- **Part G Item 19 of 2AM-DOH1323, Request for Approval of Revised Waste Rock and Ore Management Plan - Responses to Party Comments**
 - **Revisions to TMAC Resources Inc. Amendment Application No. 1 of Project Certificate 003 and Water Licence 2AM-DOH1323 – Clarification on Waste Rock and Ore Management Plan**
-

Table 1 Part G Item 19 of 2AM-DOH1323, Request for Approval of Revised Waste Rock and Ore Management Plan (WR&OMP I)- Responses to Party Comments

Engineering Drawings for the Doris North Camp Area - Pad T, Doris North Project, Nunavut, Canada Water License Amendment

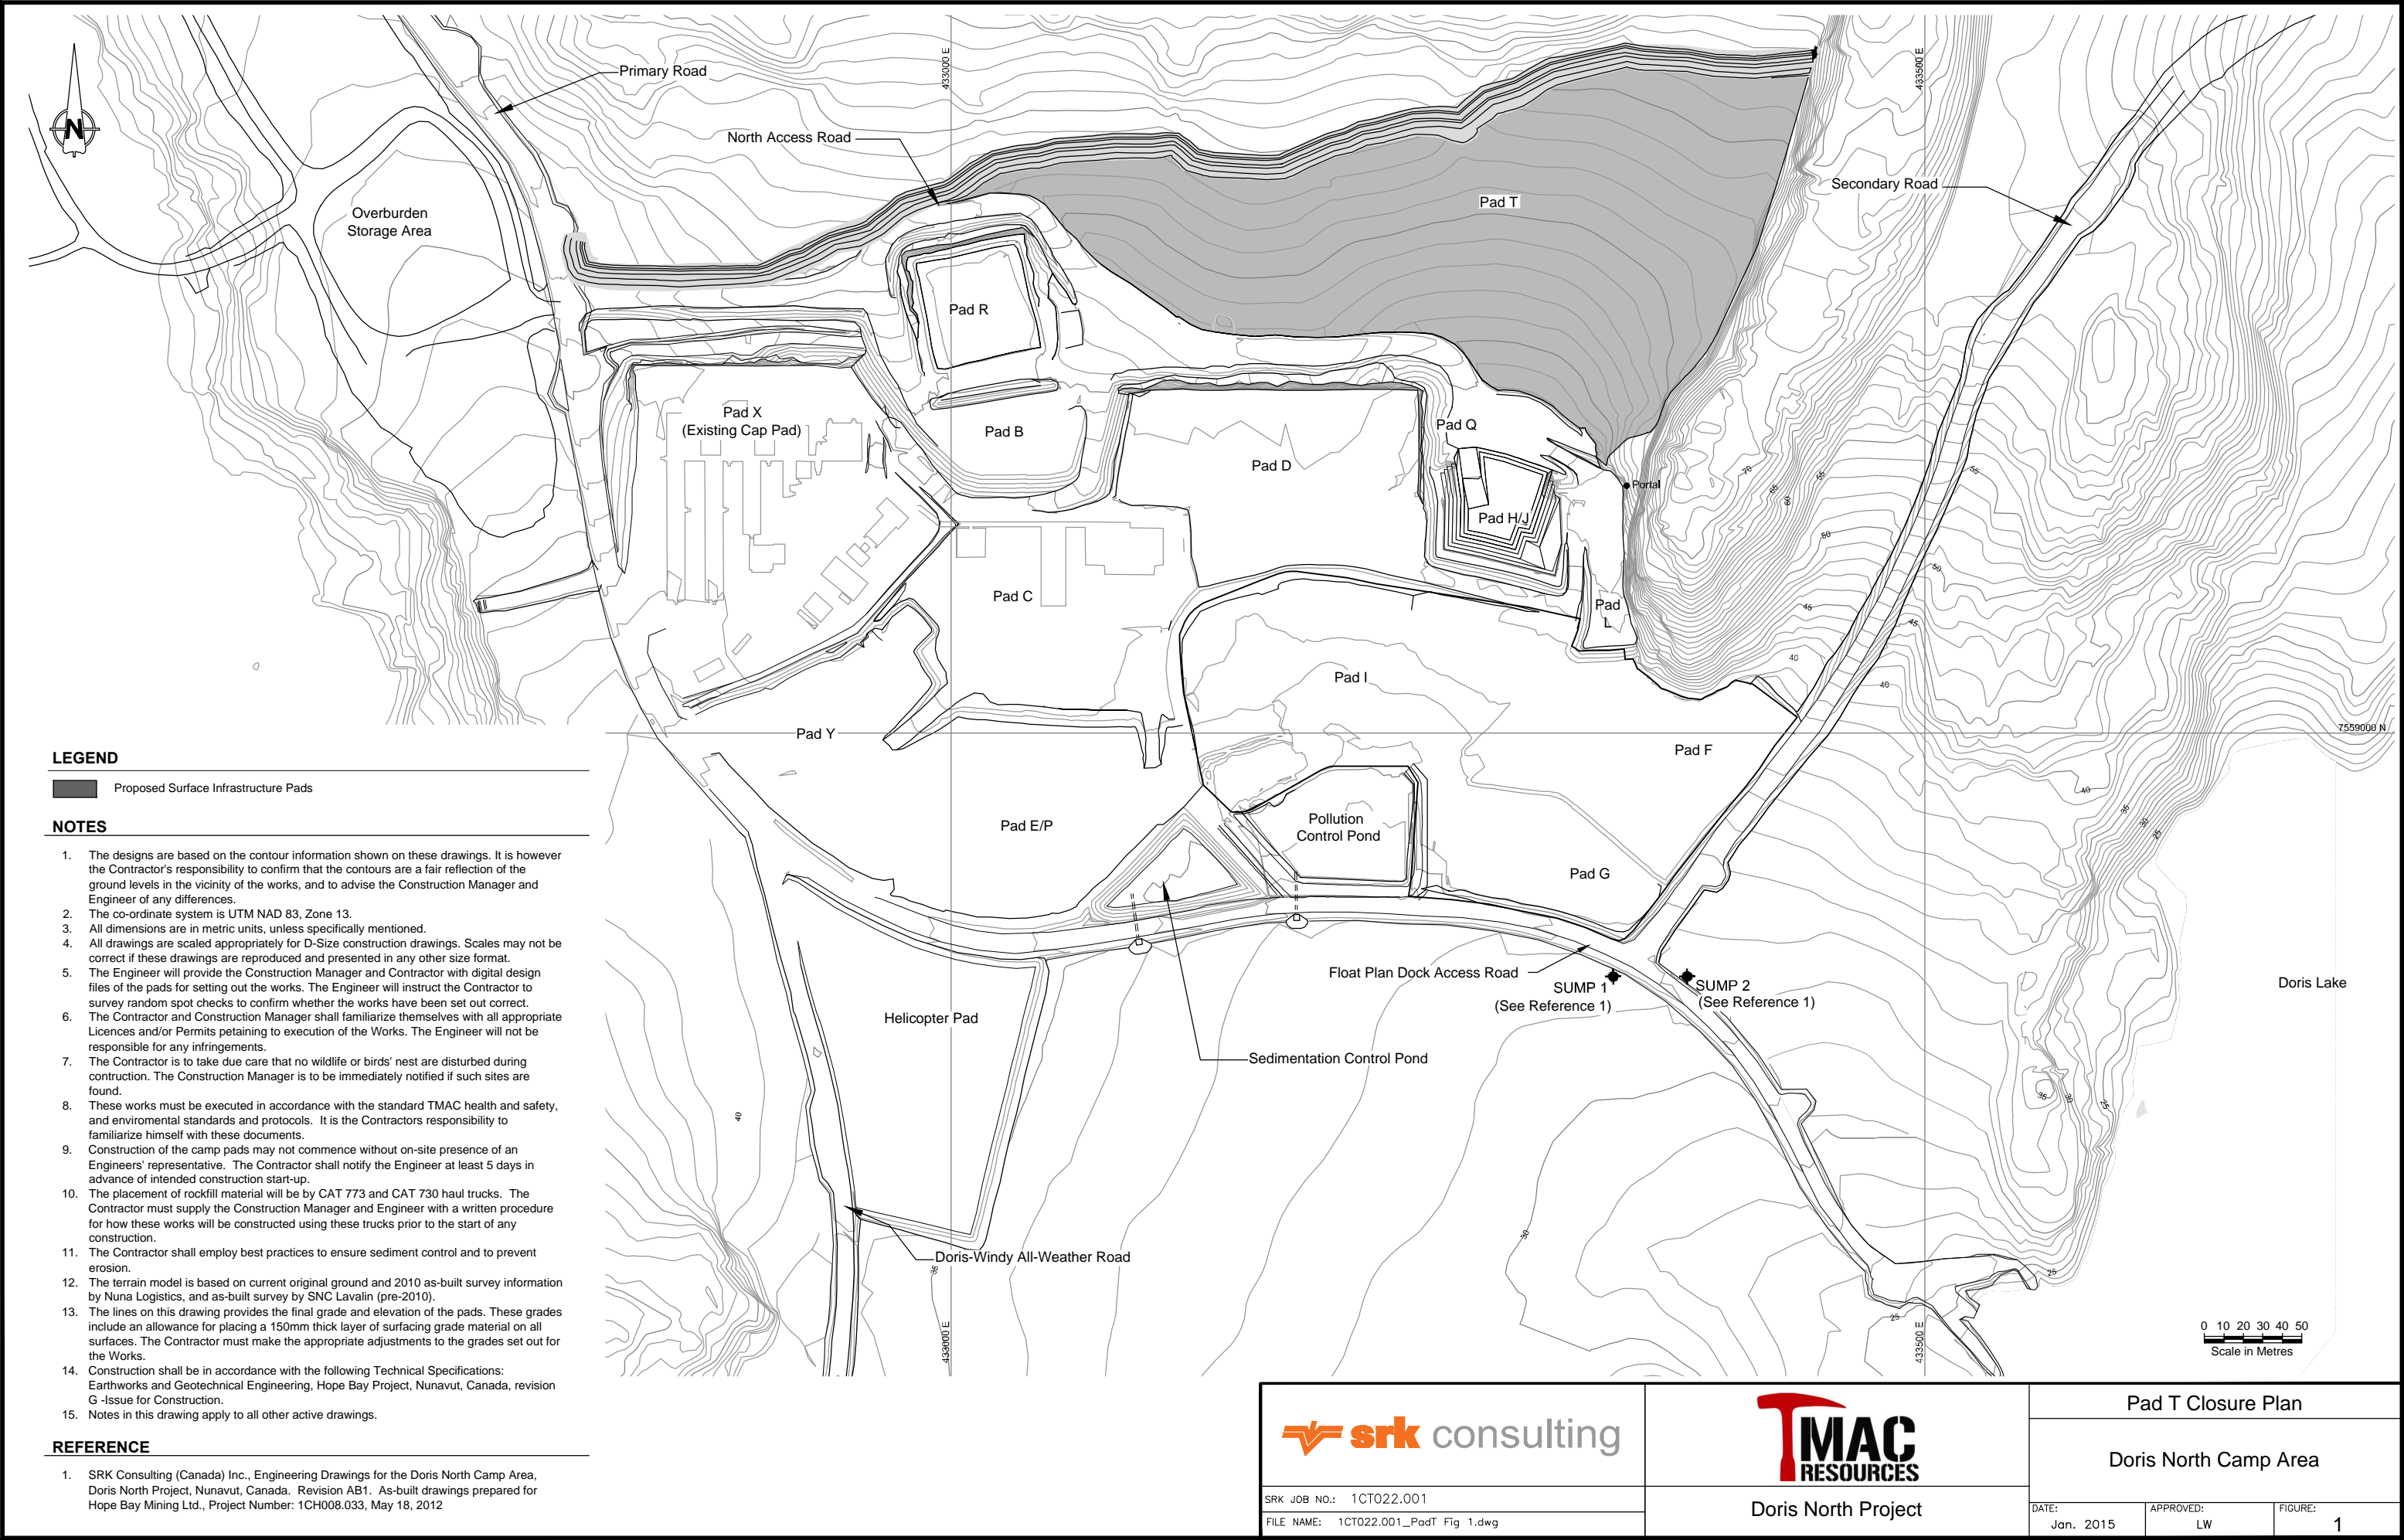
KIA June 3, 2015				
Issue #1 Stockpile Configuration				
K1	Design slope for pile	<p>Figure 3 shows 2.5H:1V on waste rock slope.</p> <p>Drawing DN-DMC-T3 shows 2.5H:1V on waste rock slope and 2H:1V on diversion berm slopes.</p>	<p>TMAC to confirm design slope for the waste rock pile.</p> <p>If 2.5H:1V is long term slope, why not construct waste dump at such slope rather than leaving possible re-sloping liability until later?</p>	<p>The long term overall slope design for the waste rock pile is 2.5H:1V.</p> <p>While it may be prudent to ensure the pile is constructed to that configuration from the outset to avoid later re-grading it should be noted that the majority of the waste rock pile on Pad T is temporary, as most of the material will ultimately be used as backfill in the mine. In addition, waste rock cannot be dumped to slopes other than angle of repose. Therefore the operational practice is to dump at angles of repose with setback benches followed by re-grading to achieve the overall design grade. This grading can either be done as dumping progresses or when all dumping has taken place.</p>

PROJECT NO: 1CT022.002.100
ISSUED FOR DISCUSSION
Revision B
March 27, 2015
DN-DMC-T0

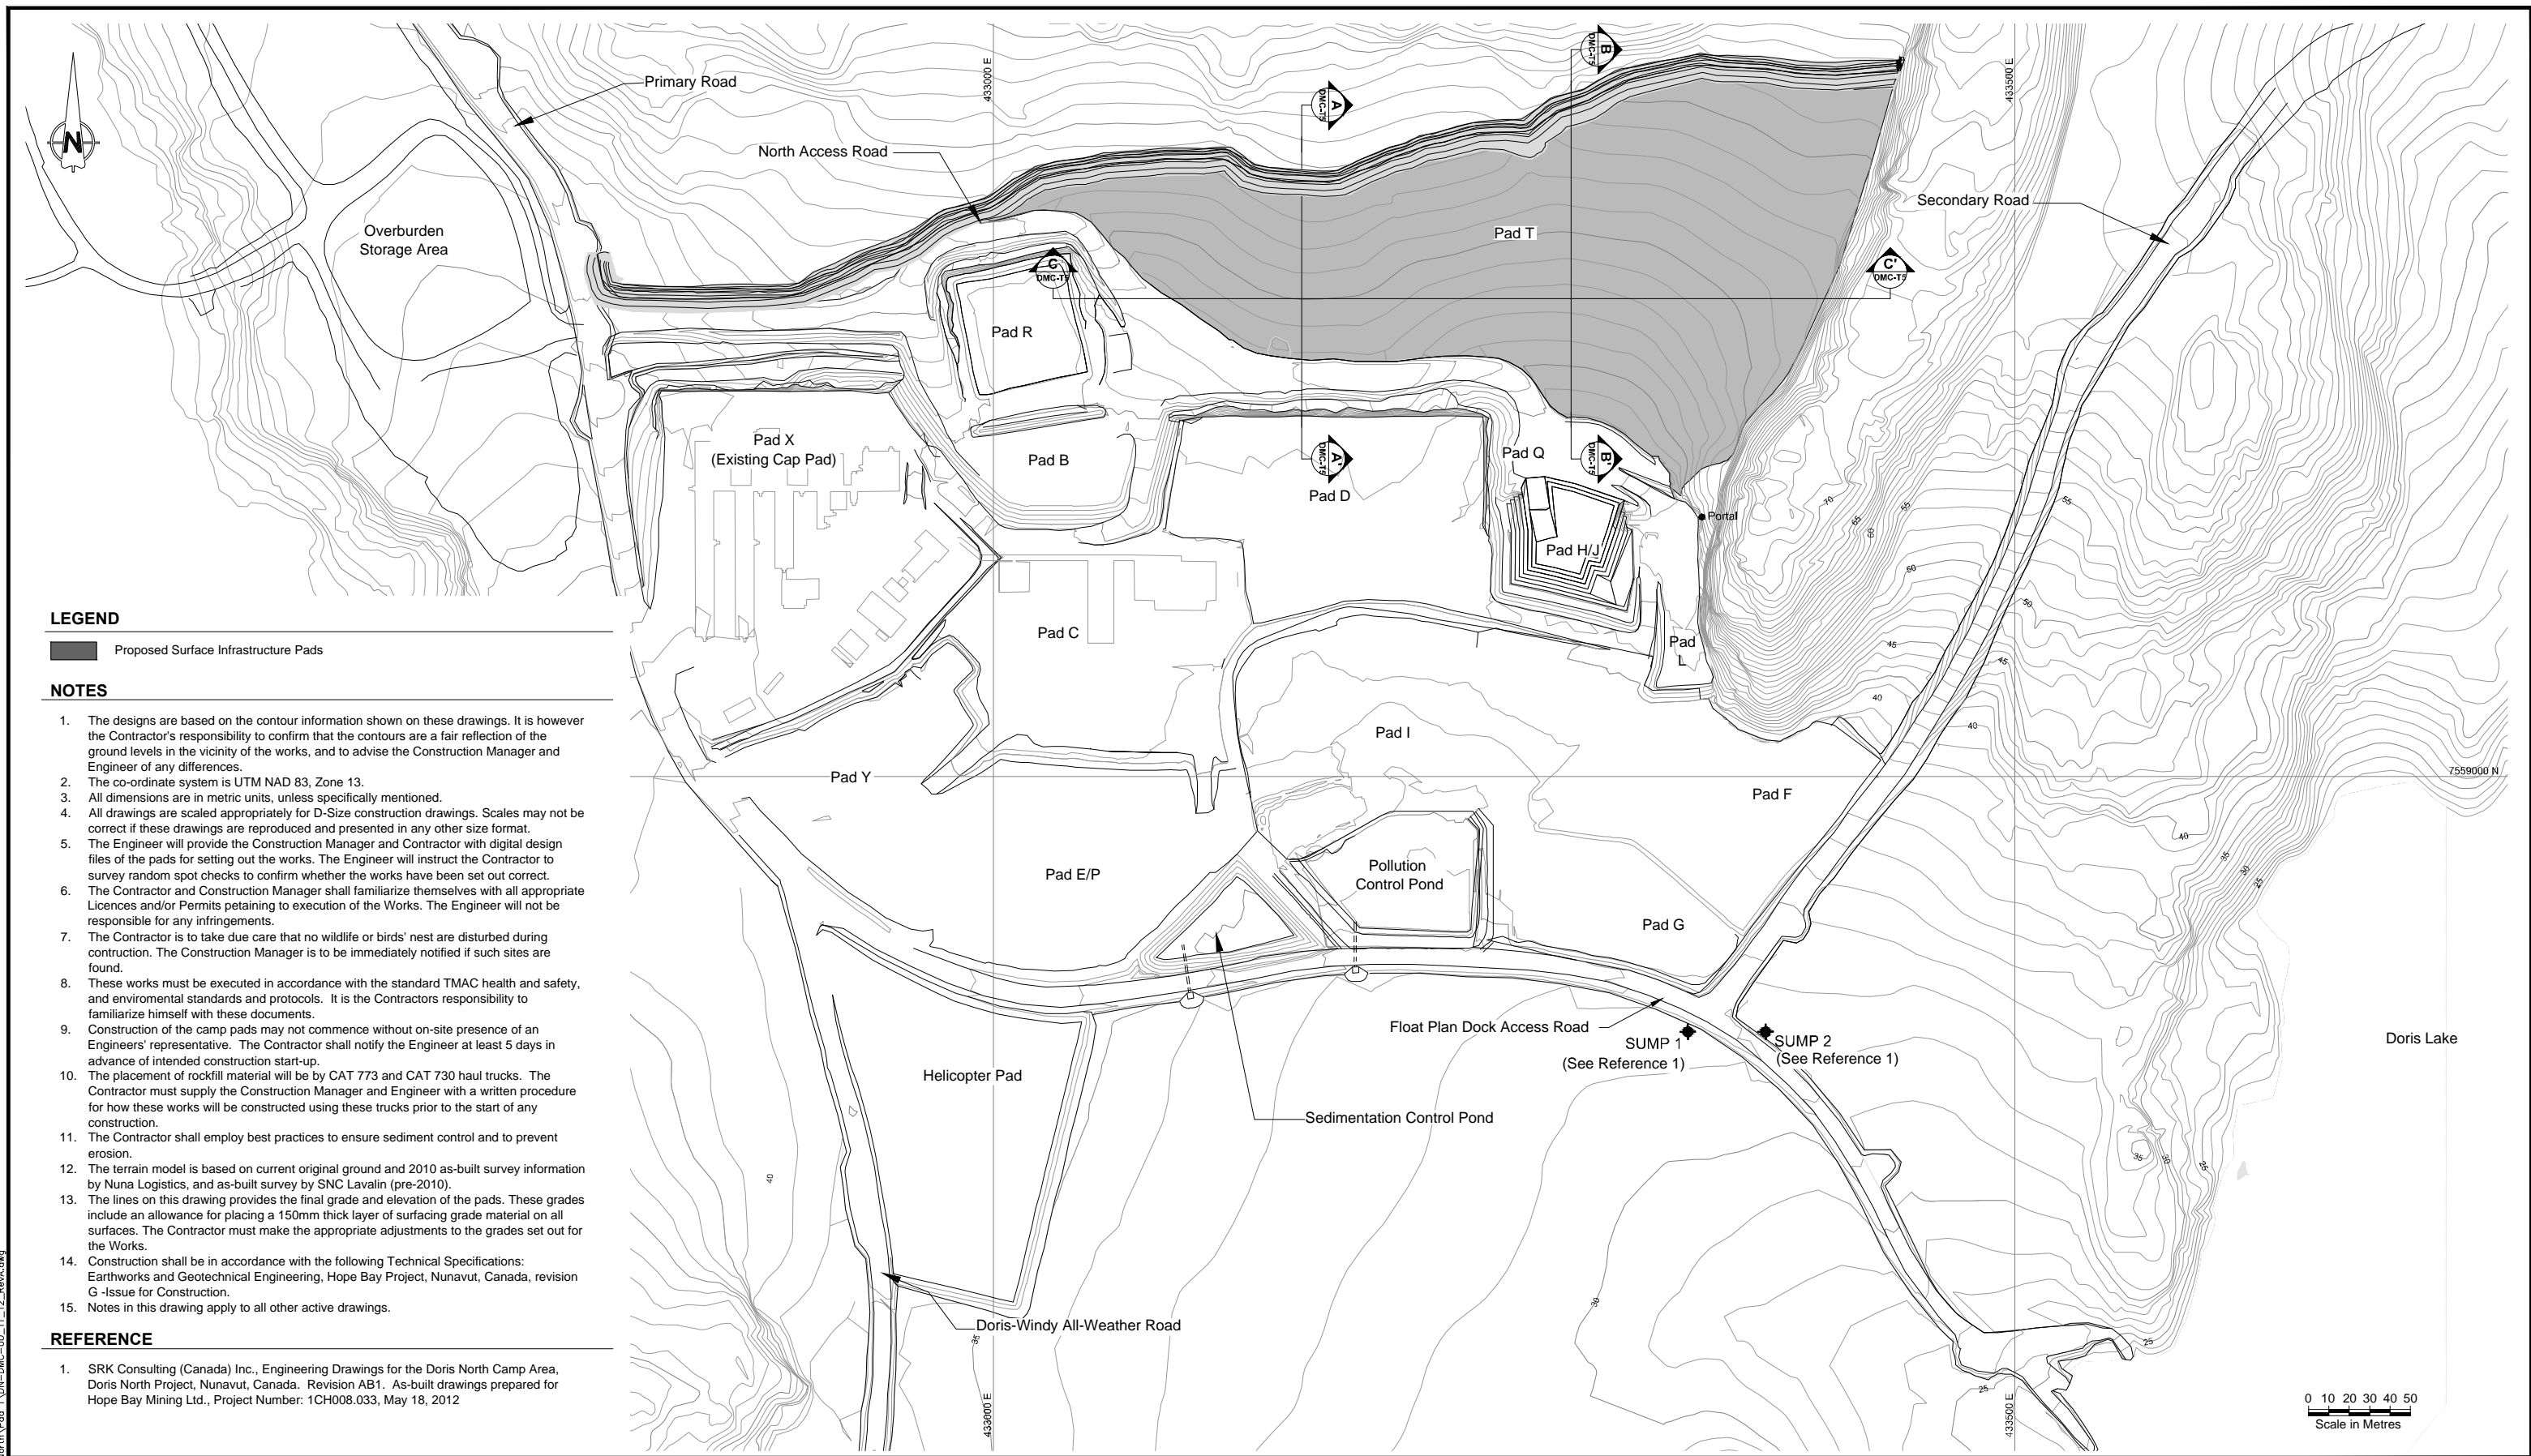
Issue #2 Water Management				
K2	Sumps	<p>All seepage and runoff from waste rock pads are directed to Pollution Control Ponds and sumps (as shown on Figure 6). No sumps are shown on associated plans or sections in Drawings DN-DMC-T0 to –T3.</p>	<p>If all seepage and run-off reports to Pollution Control Pond, why is there a need for sumps on the downstream side?</p> <p>How does the water from Pad T reach these sumps?</p> <p>Are the sumps lined to contain all contact water?</p> <p>Are there specific design criteria for the sumps to prevent overflow or seepage?</p> <p>Why are the sumps not shown on the engineering drawings?</p>	<p>Water management, including Underflow Interception Sump location, design and operation, is presented in the approved <i>Interim Water Management Plan</i>-Rev 5 (SRK 2012):</p> <ul style="list-style-type: none"> Figures 1, 2 and 3 illustrate the sump locations; Section 3.3.3 describes components of the water management system, including sumps. <p>Updated Drawing and Figures, showing the locations of Sumps 1 and 2, are provided (see attached).</p>
